Technical Service Bulletin 7

Tower Mounting Plates

June 2, 1999

This bulletin affects all 1999 M.Y. Epic 22 Boats with a HIN above B121.

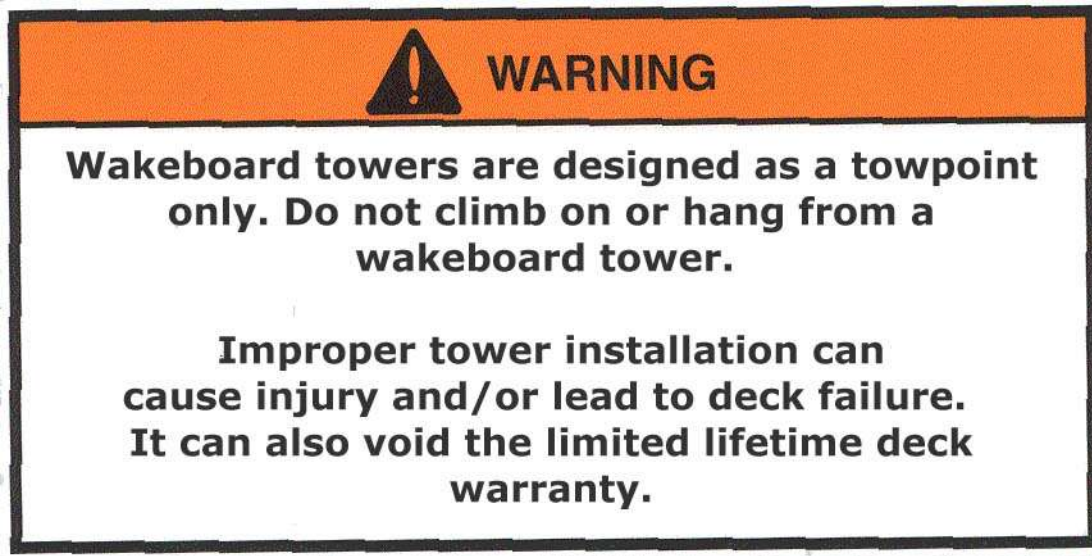
The design specifications for all Epic 22 boats have been modified to include a pair of aluminum mounting / backing plates integrated into the deck construction. This has been done to facilitate the installation of wakeboard towers on Epic 22's. These plates have been installed at the front mounting location only, the rear mount backing plates must be inserted at the time of tower installation.

MDH0011362	Backing Plate, Bow Legs, Tow Tower Install, 1-1/2"x5" w/Holes
MDH0010973	Backing Plate, Aft Legs, Tow Tower Install, 3"x8"Curved
